Figure 3
 Programmed Roadway Improvements in the Study Area
 Villages of San Carlos DRI – Time Extension Traffic Study
 Revised August 2006

LCDOT Sufficiency Checklist

Lee County Sufficiency Checklist for Planned Developments, Amendments, and Existing Developments Requesting Planned Development Zoning

DATE 11-29-06
SHEET NO. B1
DRAWING BY JBN
FILE NAME 02-110

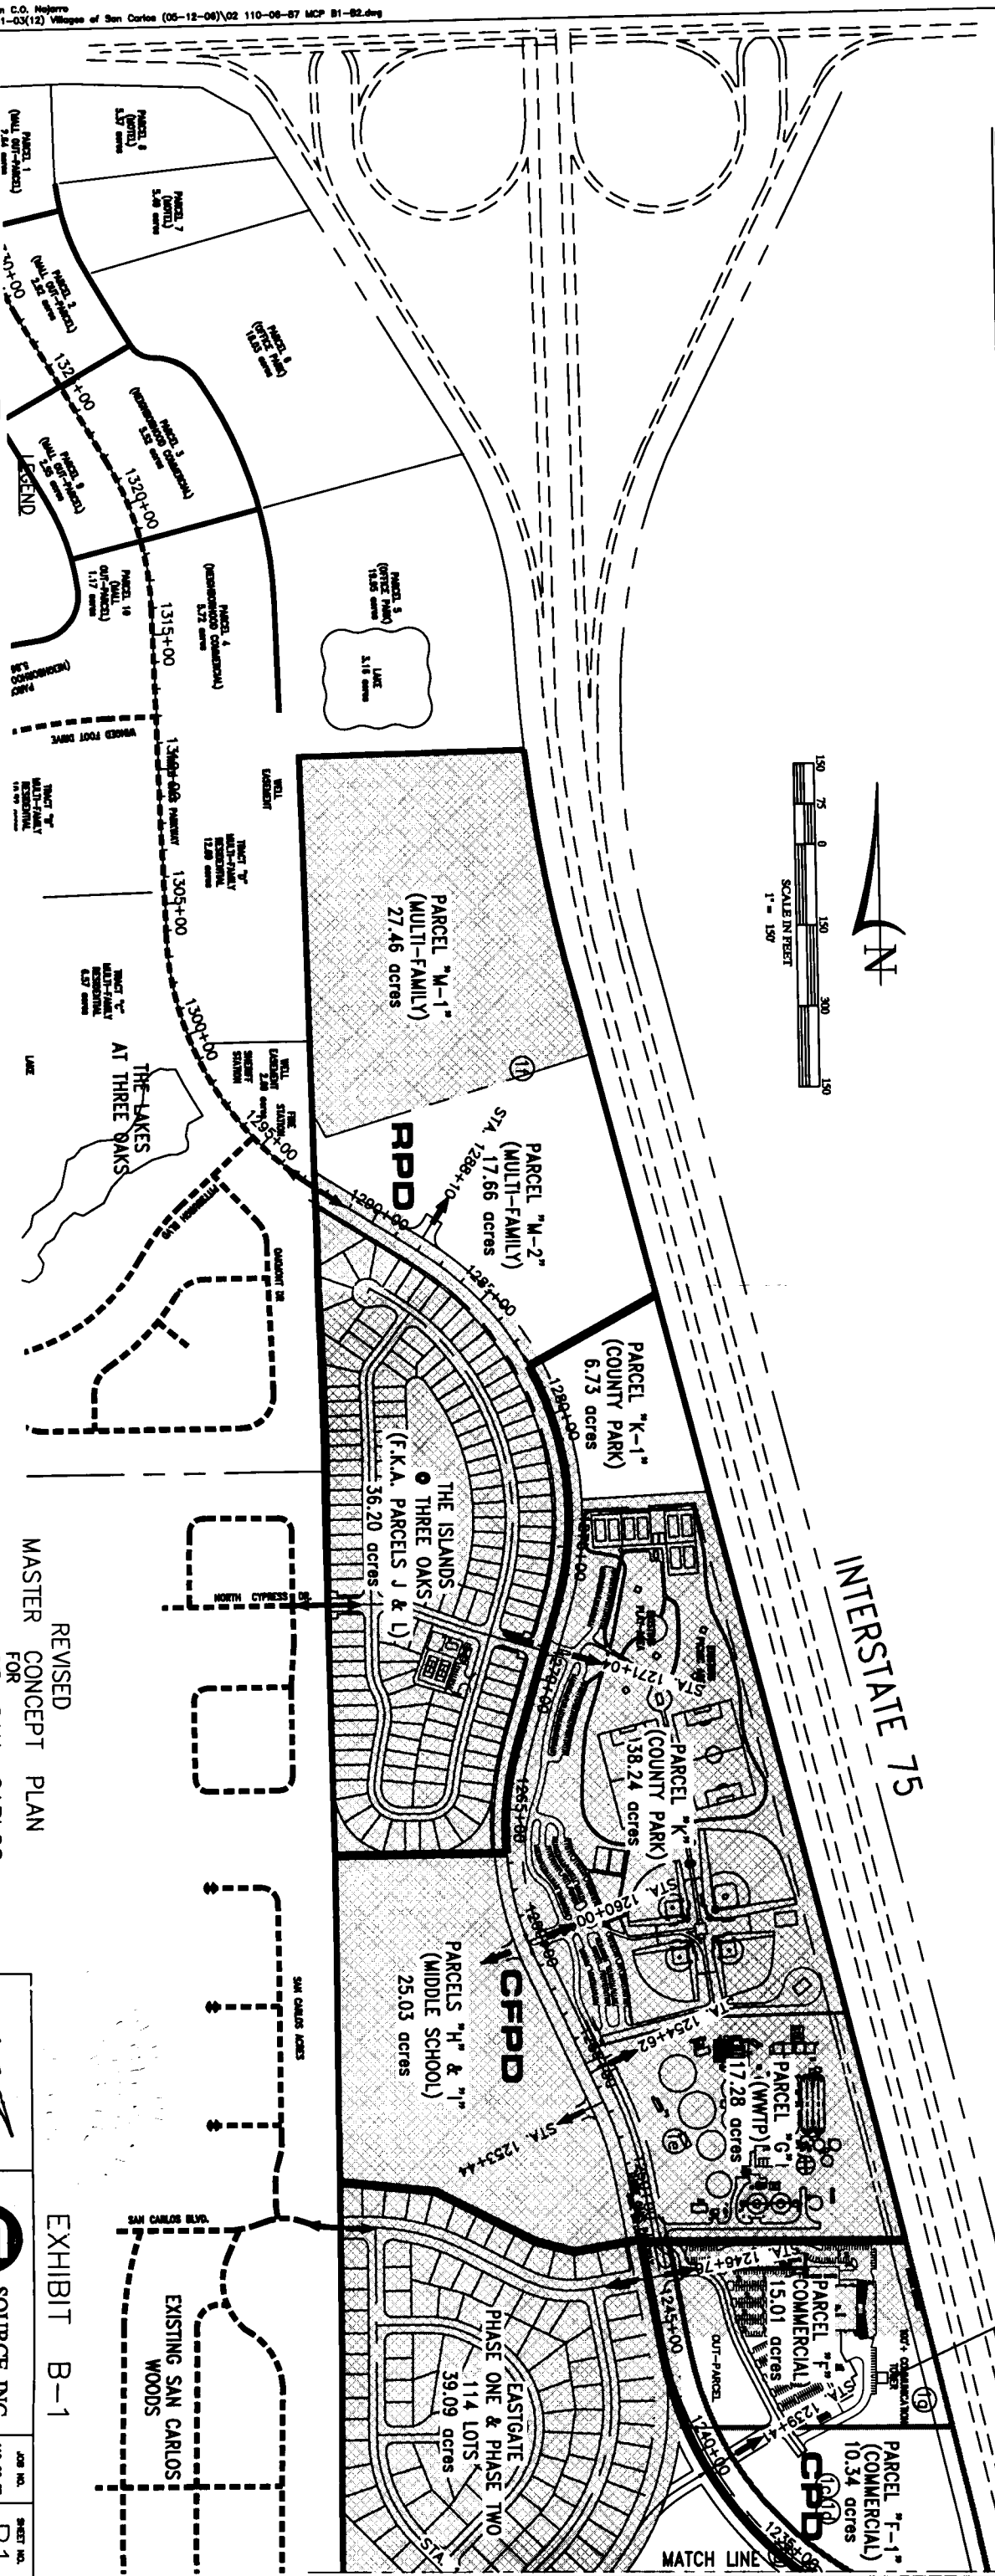
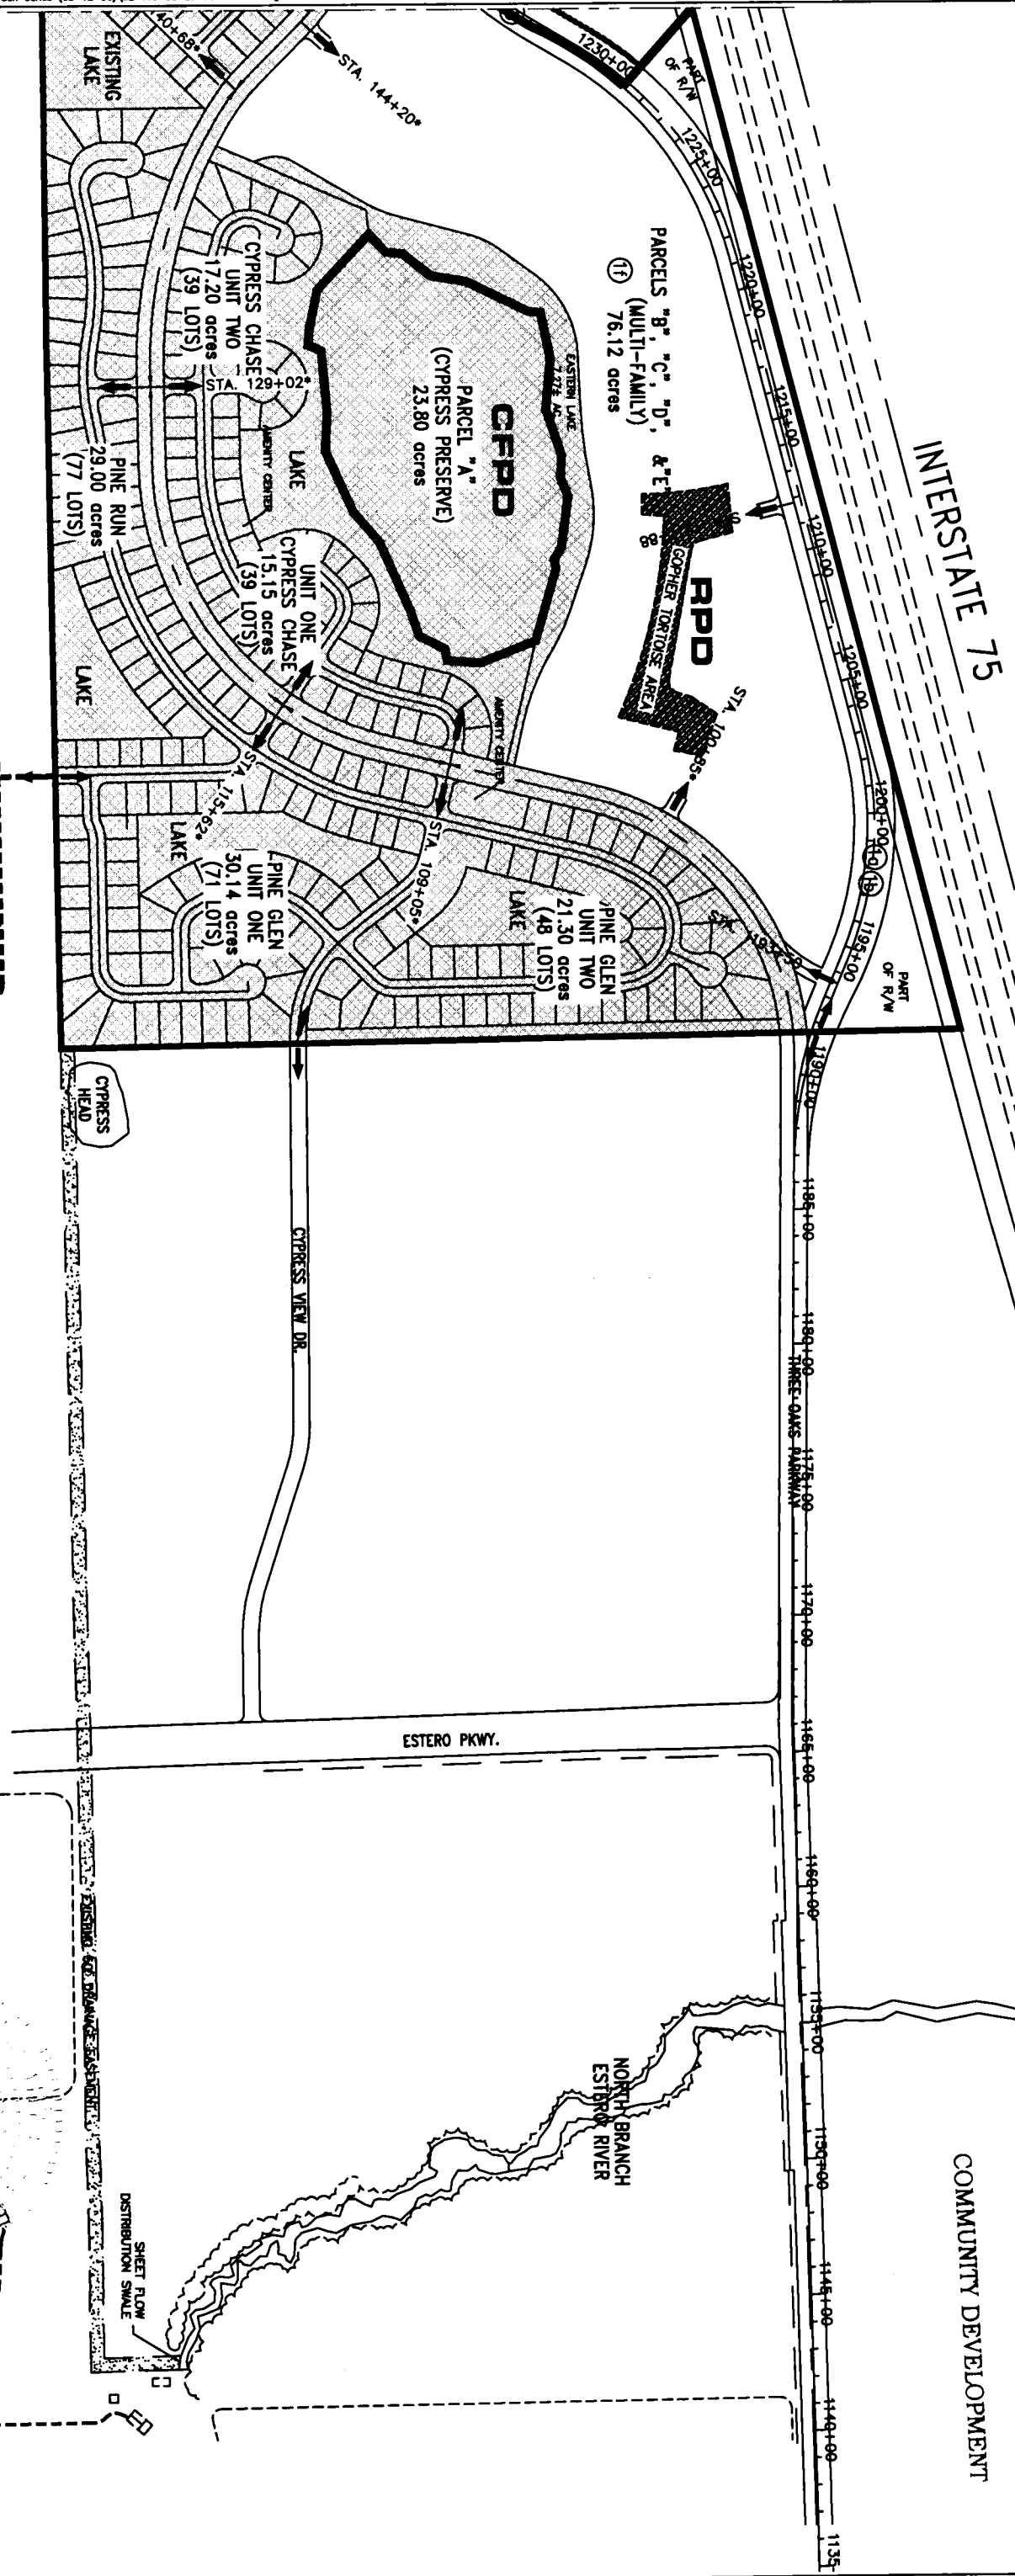
- F. The Legend, Existing Previously Completed, on Sheet B2, should also be shown on Sheet B1 for consistency.

Sheets B1 and B2, Parcels B, C, D, & E do not show the exact location of all points of vehicular ingress and egress. Please provide this information as applicable to Sheets B1 and B2.

Sheet B1 list Deviations previously approved in Resolution Z-91-083. However, the deviations are not keyed to the master concept plan on Sheets B1 and B2. Please key the deviations appropriately.

The deviation requests can be shortened on Sheet B1, since the actual deviation request and condition are in the body of the zoning resolution. Therefore, staff recommends that the deviation

language on Sheet B1 be more cryptic. Using Deviation 1 as an example, Deviation 1 would read: Deviation 1, for all districts, approved as conditioned.

The proposed MCP is a two sheet exhibit labeled as Exhibit B-1 (which includes both sheets B1 & B2), information, notes and legends found on one sheet, applies to the entire exhibit (i.e. both sheets). For clarity, we have added the legend to both sheets.

The list of deviations shown on sheet B1 are those that were previously approved and utilized in the development of the project so far. Only one of those deviations had a "specific location" associated with it . These deviation locations were "defined" and not "keyed" on the previously approved MCP. We therefore have included them the same way as what had been previously approved.

Aug 28, 2007 - 4:31pm C.D. Mojero
Z:\Current Projects\110-01-03 (12) Village of San Carlos (05-12-06)\02 110-06-87 MCP B1-B2.dwg

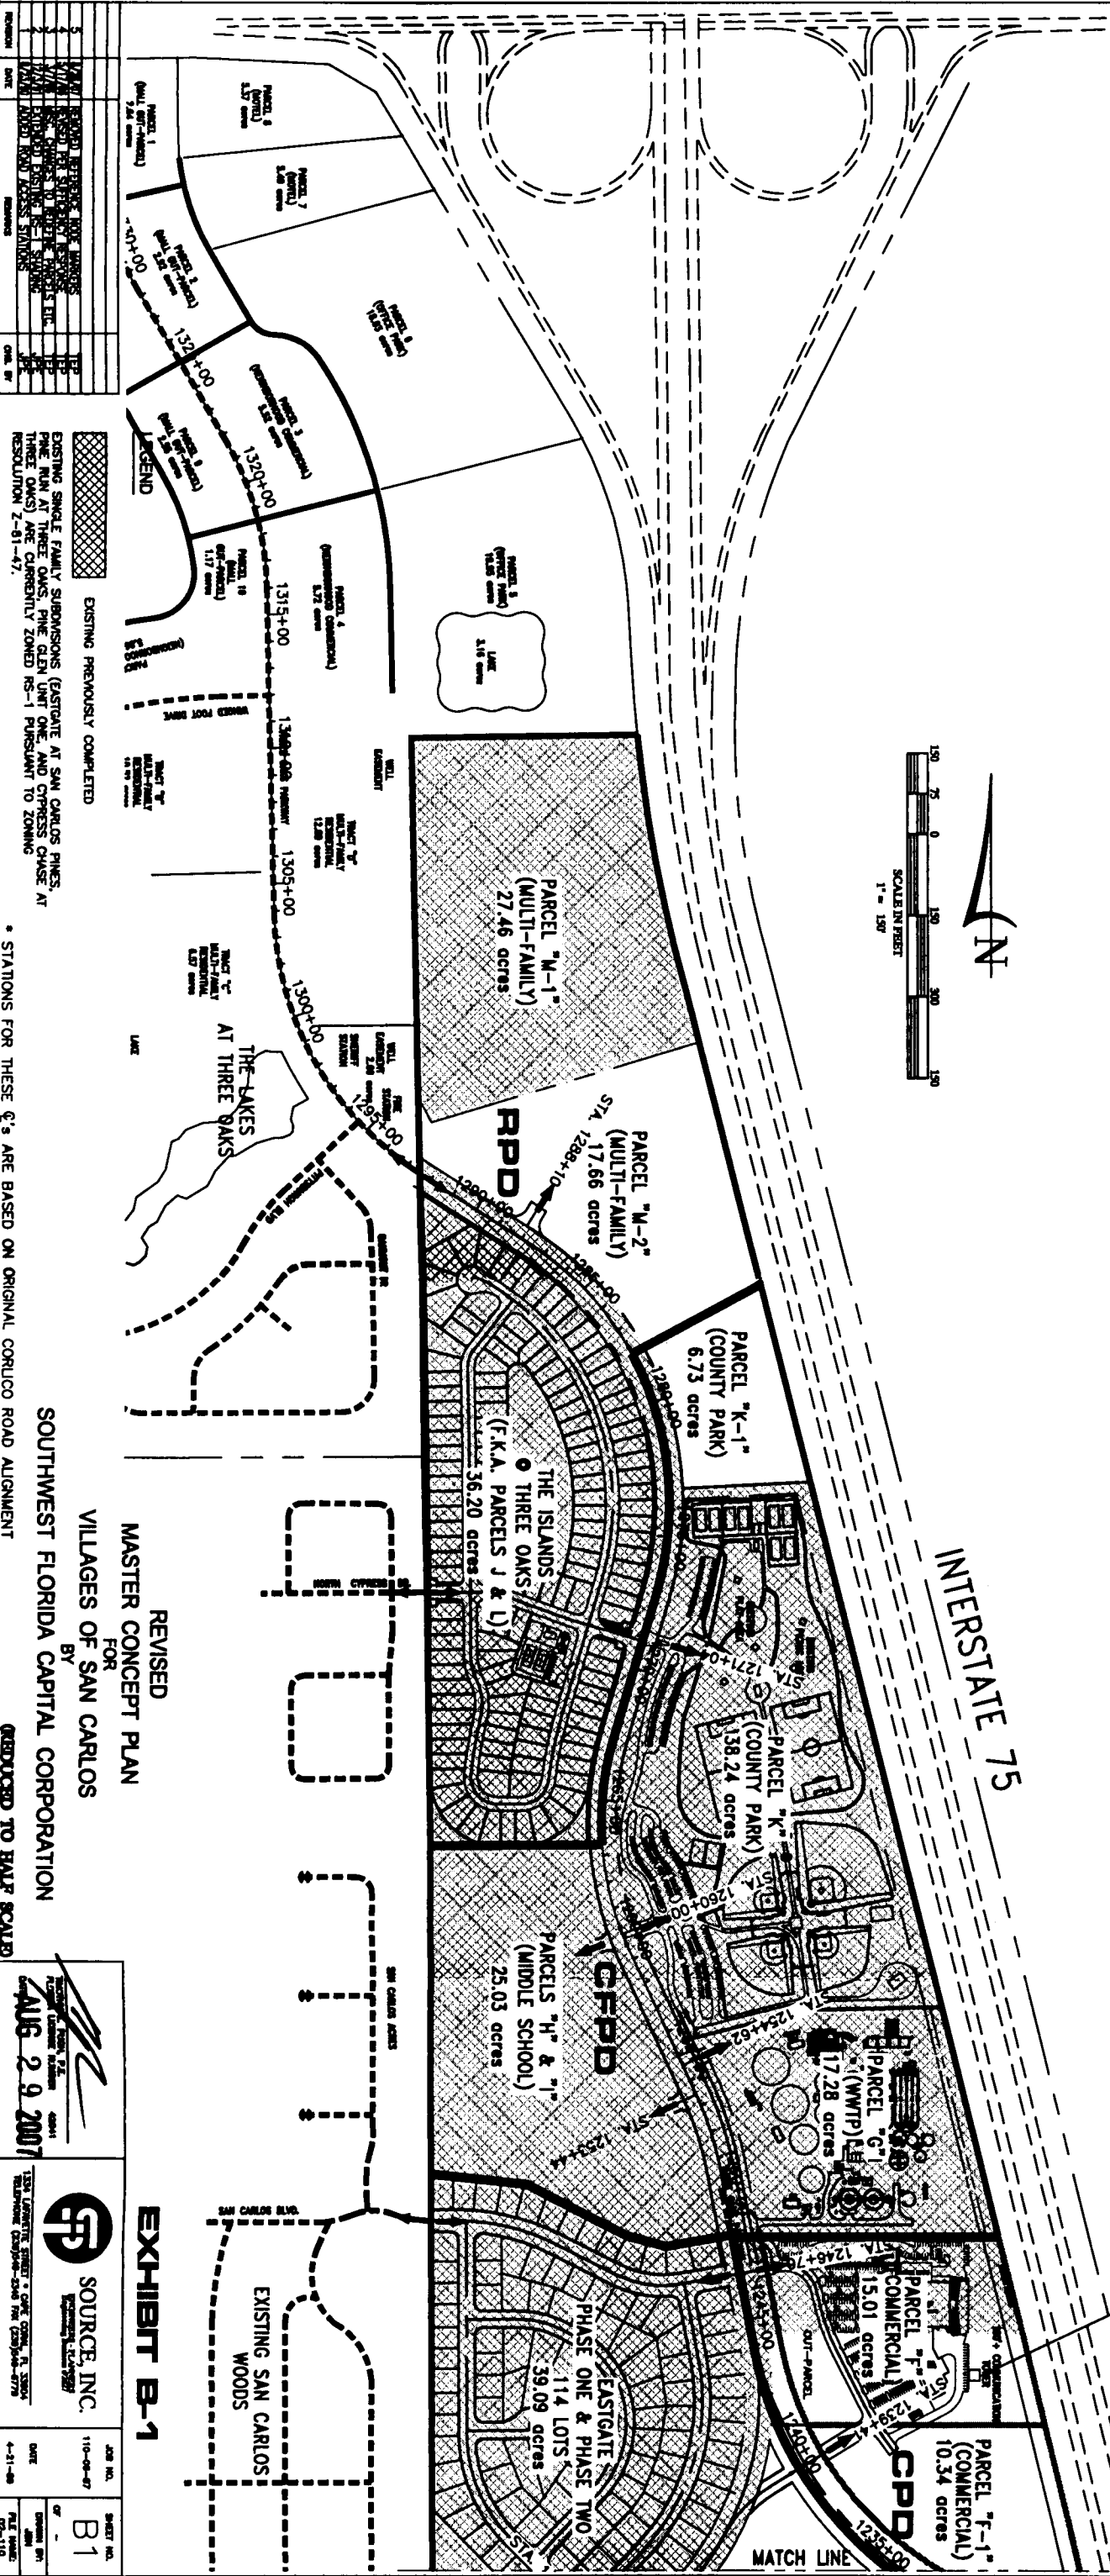
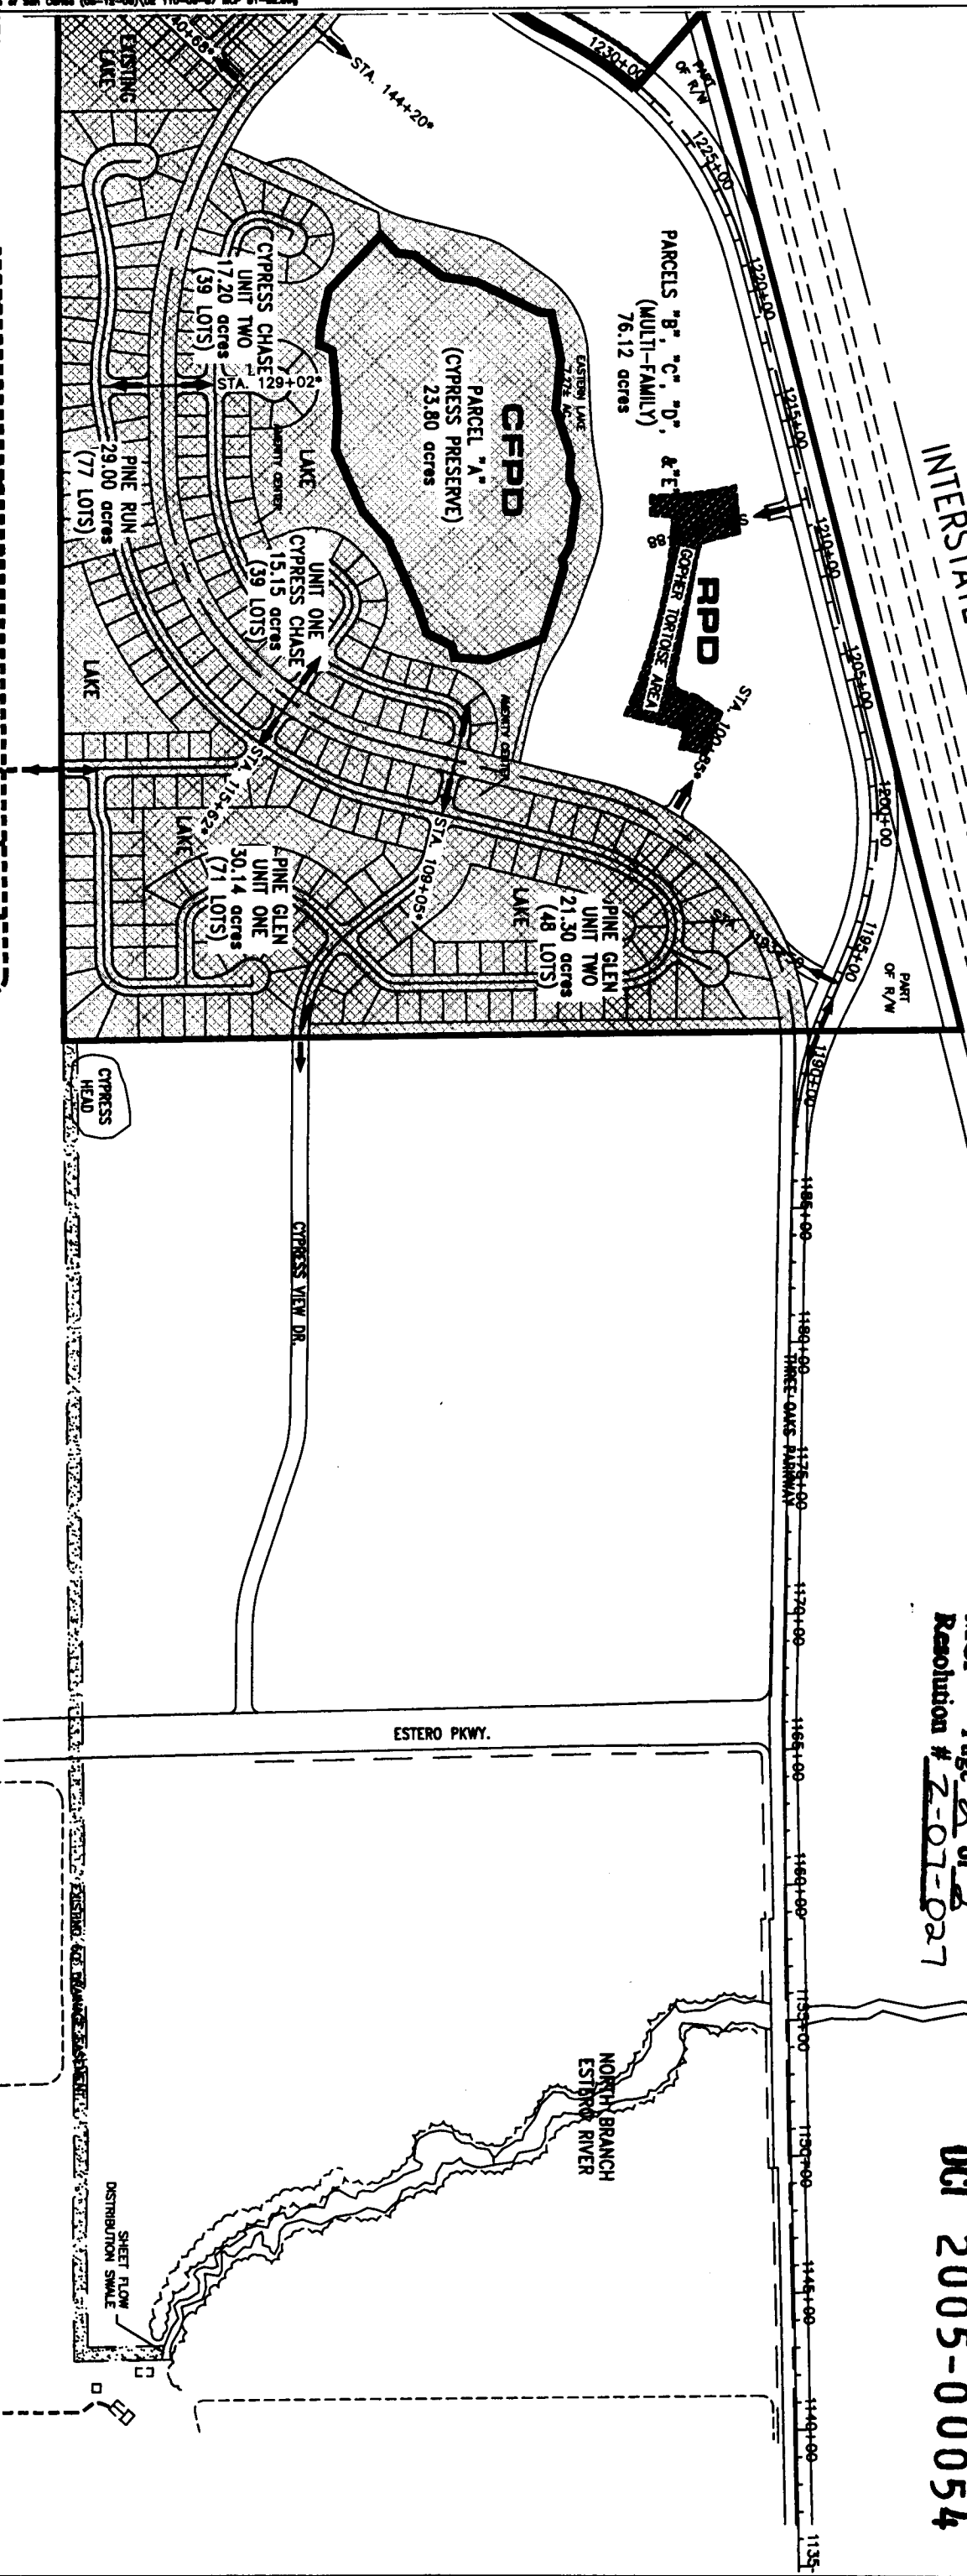
Sheet B2 lists the Villages of San Carlos Currently Approved Schedule of Uses. This should read Villages of San Carlos Schedule of Uses and the Schedule of Uses must be revised to reflect the current LDC uses. The "Proposed Changes to the Previously Approved Schedule", as shown on Sheet B2, must be incorporated into a new Schedule of Uses for the development.

- D. Sheet C2 shows the typical lake x-section. This must be relocated to Sheet B2 where it was originally located on the master concept plan for Resolution Z-91-083.

- E. Sheet B2 shows Parcels B, C, D, & E combined for residential. These parcels were originally shown as multiple family high density (Parcels E and D) or multiple family low density (Parcels B and C). Please indicate on Sheet B2 if these Parcels will be Multiple family low density or high density. This would be consistent with the DRI Revised Land Use Table which has acreages assigned to Parcels B, C, D, & E.

The Schedule of Uses shown on Sheet B2 is the list that is "currently approved" for this development. The notation below labeled "Proposed Changes to Previously Approved Schedule of Uses", details what changes are being proposed. We can provide, or staff can compile, a composite list of all of the uses that would be allowed by executing those "proposed changes".

Today the Schedule of Uses are incorporated into the body of the zoning resolution and you may want to delete the Schedule of Uses (both current and proposed) from Sheet B2 and recreate the Schedule of Uses on a separate exhibit that can be worked into the body of the zoning resolution.

The typical lake cross section has been added to the sheet B2.
